Proposal for the addition of a lateral
facing carrycot icon to the module
labeling options.

Format review of module label

Improved for 63nd IG

Erik Salters,
Dorel

Current R129-01

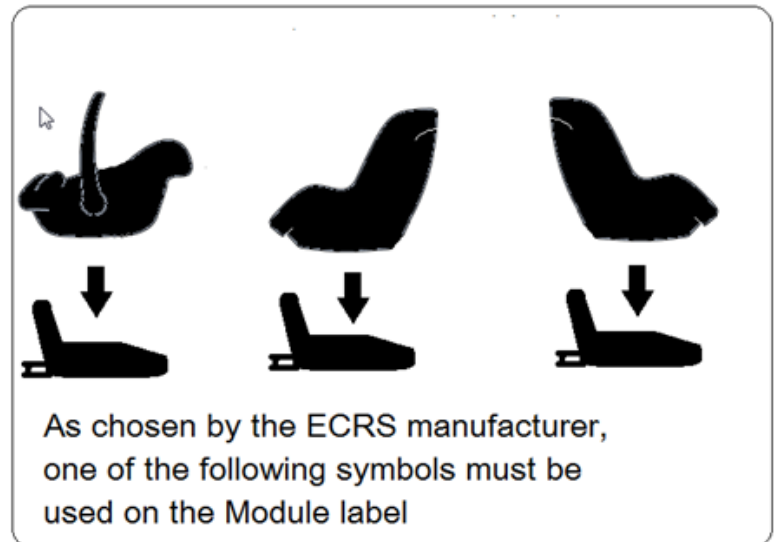
- Current R129-01 depicts following label to be placed on a module:

62nd IG work

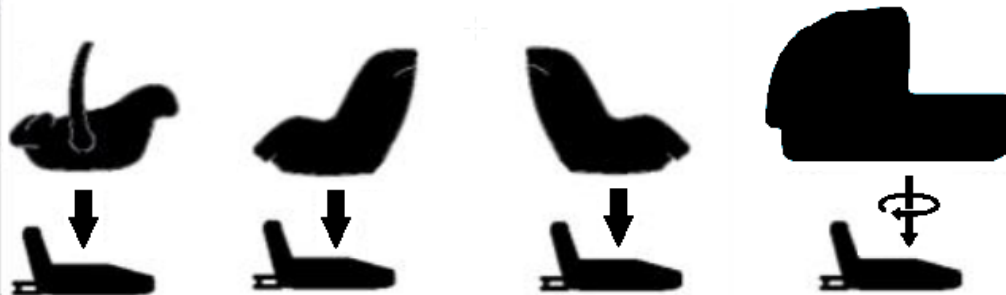
- In the 61st meeting a proposal to add a Lateral facing carrycot was presented.
- Different arrow requested for the lateral facing carrycot (Vti, ANEC; @ 61st meeting)
- New suggestion:

By choice of the ECRS manufacturer, one or more of the following symbols must be used on the module label

62nd IG accepted a new proposal

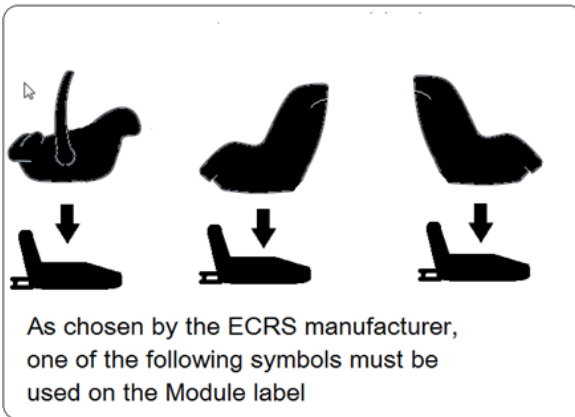
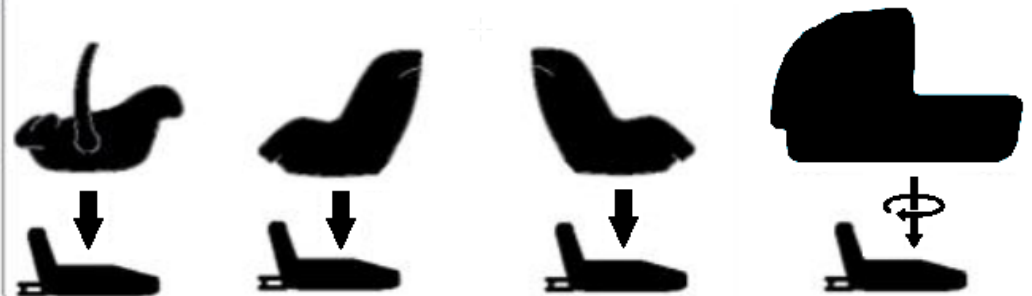
Module label

New

Module "name of module"
45cm - 75cm / <12kg

'Brand name", "modelname"
R129-022439

By choice of the ECRS manufacturer, one or more of the following symbols must be used on the module label

Challenges identified @ GRSP (after the 62nd IG)

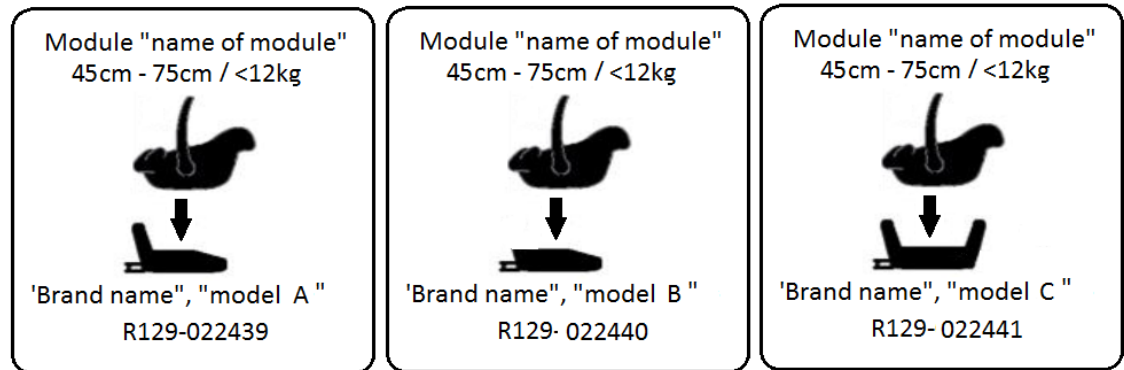
1. What if a module can be used on multiple bases; how to identify the different bases?
2. What if a babyshell can be used stand alone and in combination with a base? This requires Approval info + Module info.
3. If a Module can be used in multiple directions, each direction could have a different usage wrt size range; how are those size range limitations communicated?

A. Multiple module labels on one module?

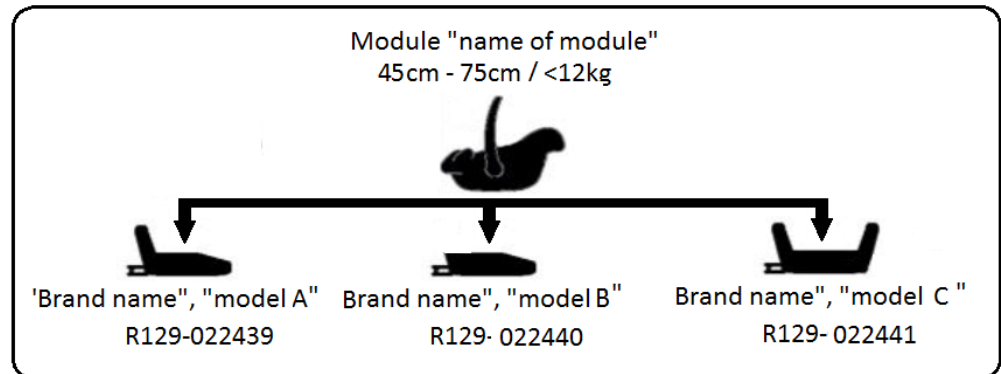
1. What if a module can be used on multiple bases?

Propose to require that each base is identified. 2 suggestions:

B. One module label with ref to different bases inc homologation numbers?

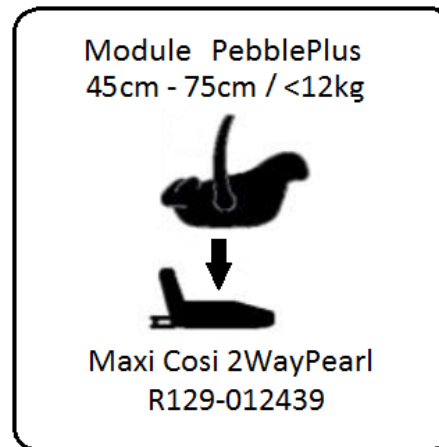
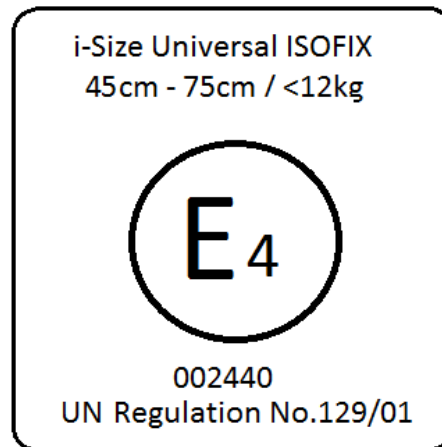
CLEPA
preference →

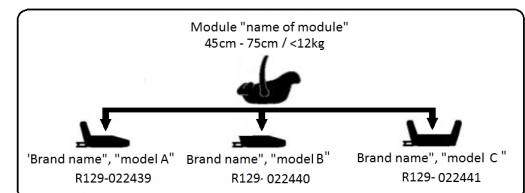
2. What if a babyshell can be used stand alone and in combination with a base?
3. Proposal; refer to both in a separate label:

Note; combined with the answer of question 1, we thus get this:

or this:
